Exhibit 4: Proposed Route
Prestonsburg - Thelma
Transmission Line
Rebuild Project

Kentucky Power Company
KPSC Case No. 2025-00346
Commission Staff's First Set of Data Requests
Dated January 14, 2026
Page 1 of 2

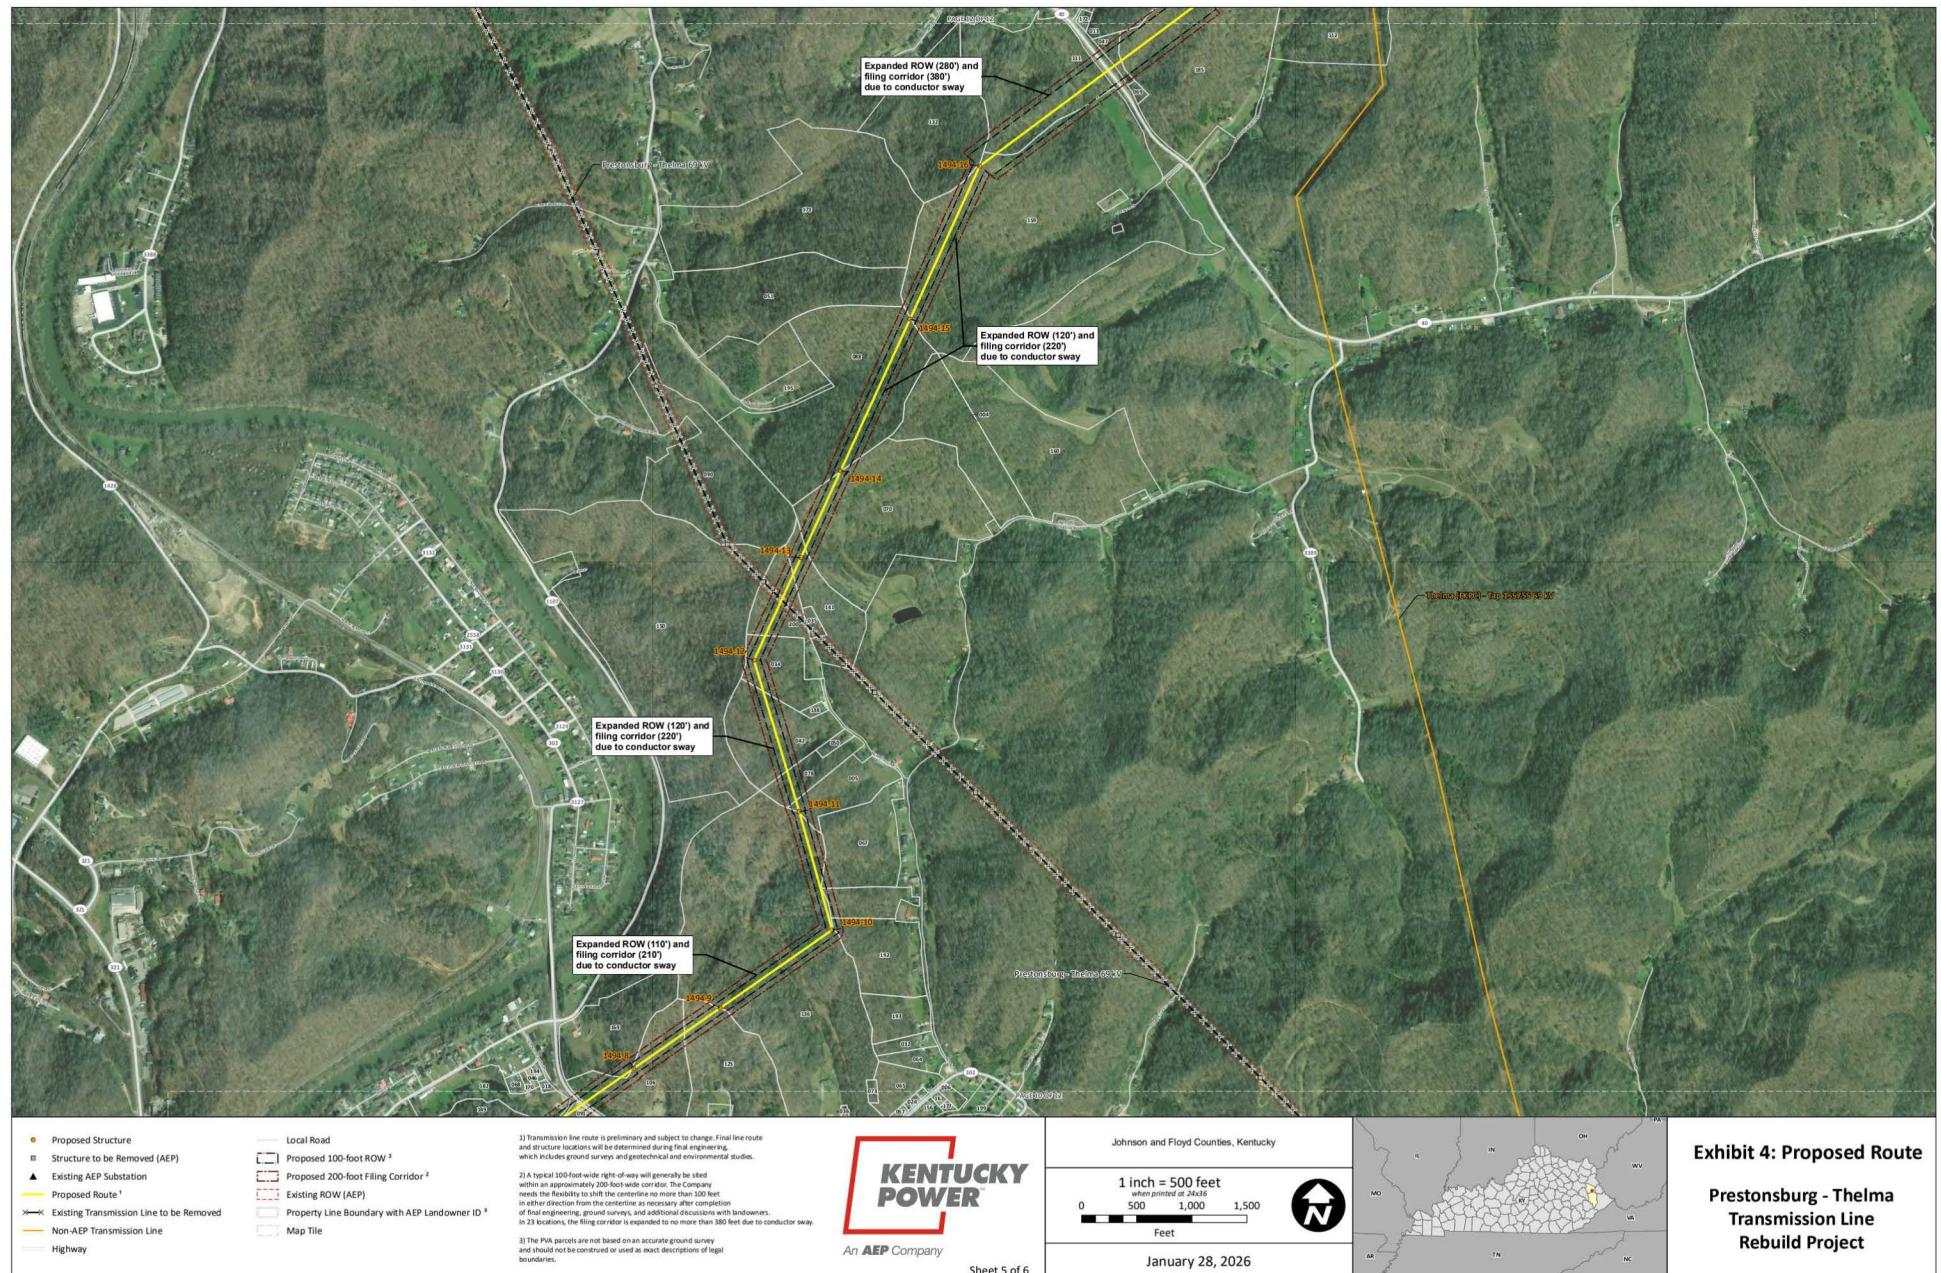
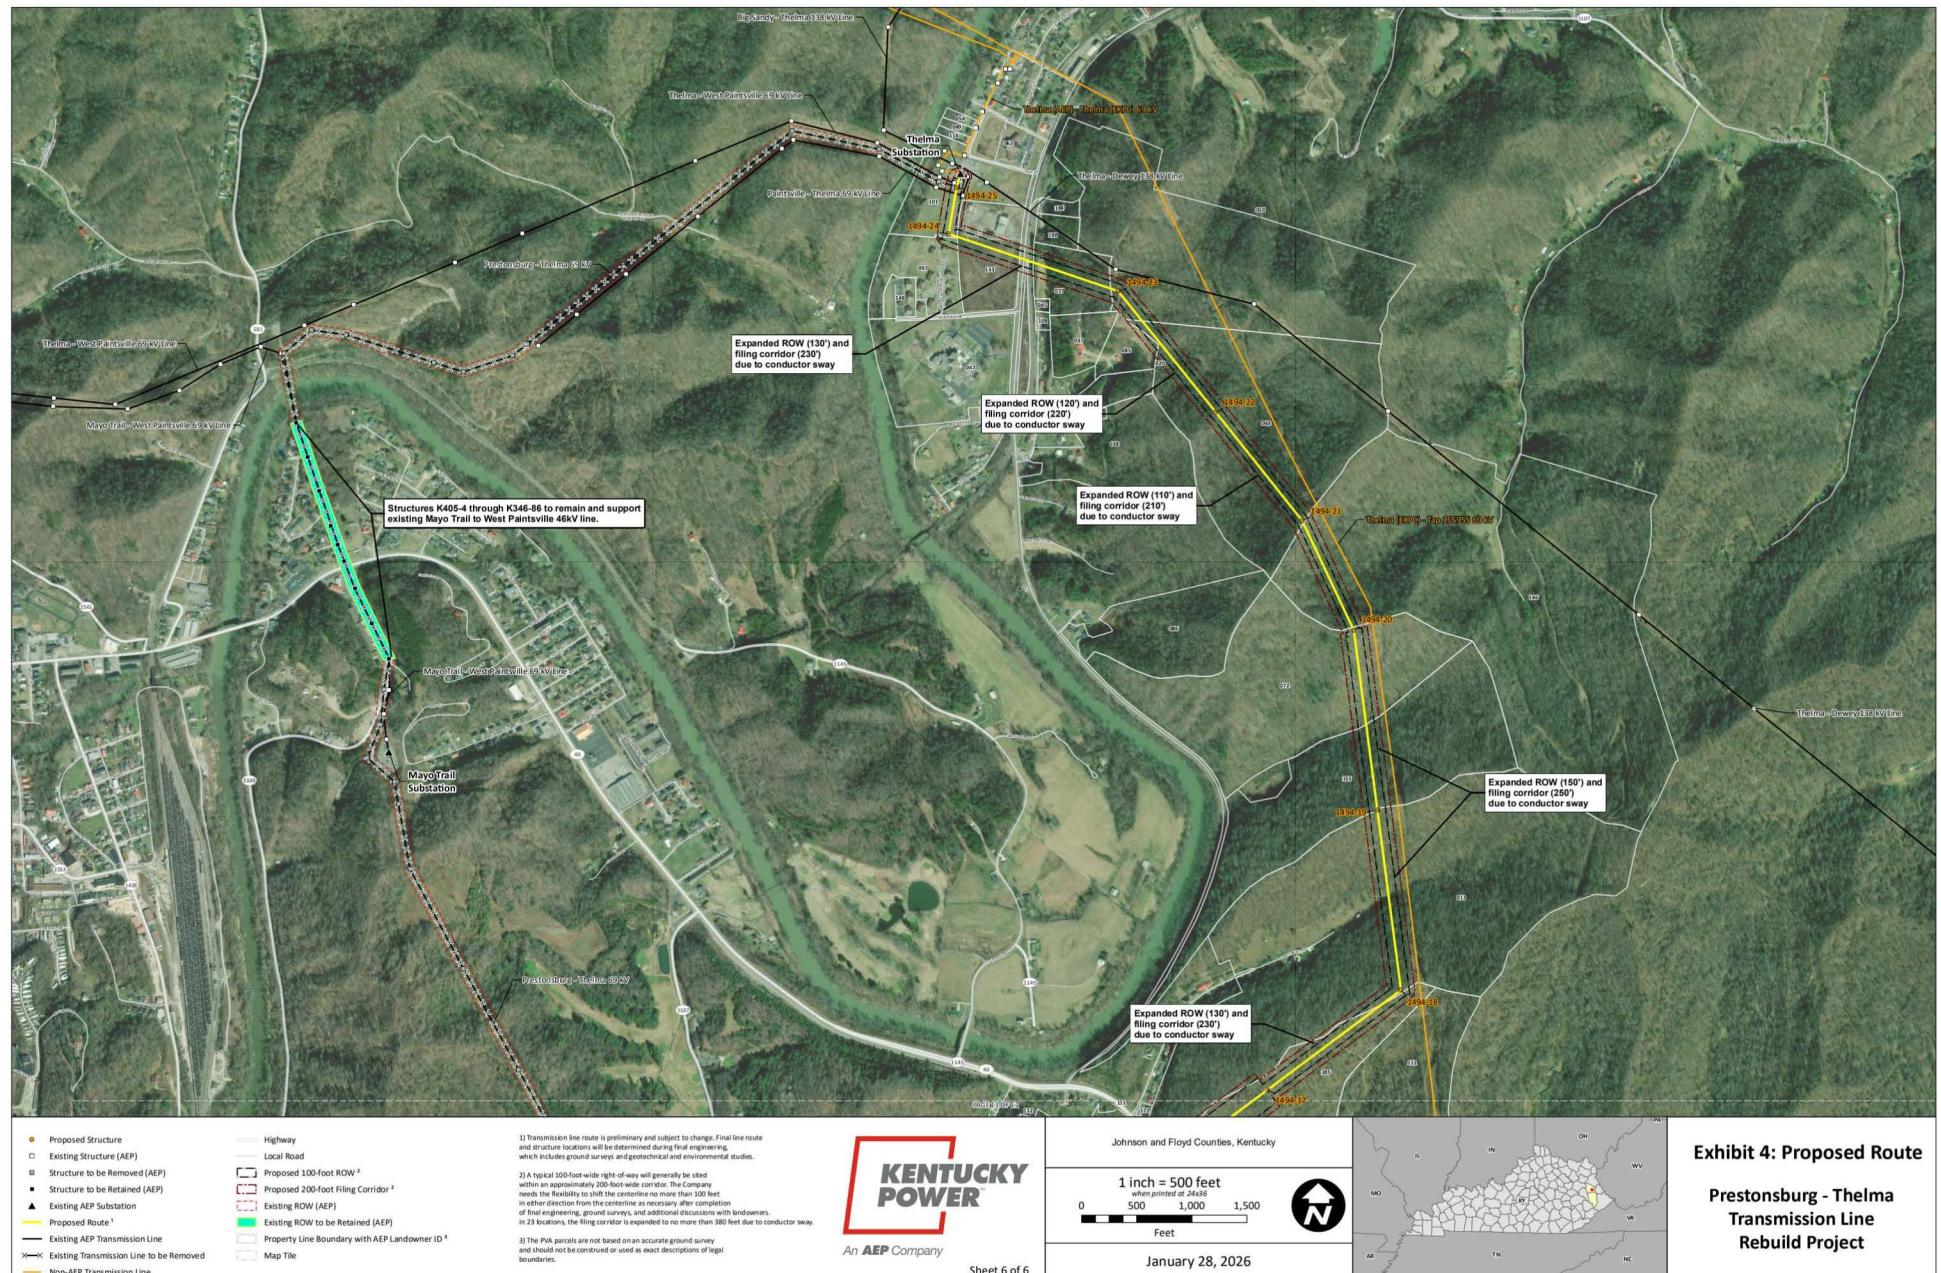
KPSC 1_19 Refer to the Direct Testimony of J. Scott Woody (Woody Direct Testimony), page 8, lines 10–23 and page 9, lines 1–21. Refer also to Application, Exhibit 4.

- a. Explain whether Kentucky Power intends to clear the entirety of the ROW for each span for this project. If not, provide a description of the span and why no total clearing is planned.
- b. If Kentucky Power does not anticipate clearing the ROW according to the various listed span ROW widths to account for conductor sway, explain the purpose of varying the ROW widths and how that comports with the North American Electric Reliability Council (NERC) standards for 69 kV transmission lines. Include in the response what the standards are for acceptable sway for 69 kV transmission lines.

KPSC 1_20 Refer to the Application, Exhibit 4 and Woody Direct Testimony, page 3, lines 4–21.

- a. Provide an updated map similar to Exhibit 4 with the structures relabeled to conform to the descriptions in Mr. Woody's testimony and depicting the ROWs that may be retained and those to be relinquished.
- b. On the map to be provided in part a of Item 20 include the other transmission lines in the area that are supported by existing transmission line structures and or interconnect with the Thelma substation, Kenwood substation, the Prestonsburg substation.

- a. It may not be necessary to clear the entirety of the ROW for each span of this Project. Conversely, there are some spans that may require additional ROW and clearing within that additional ROW, as described in Company Witness Wolffram's and Company Witness Woody's direct testimonies. Generally, the width of secured transmission line ROW should be sufficient so that the installed facilities can operate to their full design capacity without limitations from current or reasonably anticipated changes in land use within or beyond the limits of the secured right of way. To meet this principle, ROW widths encompassing conductor sway are included in this filing. Vegetation clearing plans will be developed prior to construction including identification of danger trees and areas where existing trees may be left. Where vegetation within the ROW does not negatively impact the function of the transmission line or public safety, vegetation within the ROW limits may be maintained. An example of this includes valley spans where the conductor-to-ground clearance under maximum sag conditions exceeds 100 feet.

- b. Generally, the width of ROW clearing will coincide with the ROW widths needed for conductor sway. As noted above, vegetation management may allow vegetation within the ROW when it does not negatively impact the transmission line or public safety.

a. Please see KPCO_R_KPSC_1_18_Attachment1. Please note that the sections of the existing line that support underbuild or parallel transmission lines will be retained. The Company has not yet determined whether it will maintain or relinquish its current rights with respect to existing ROW.
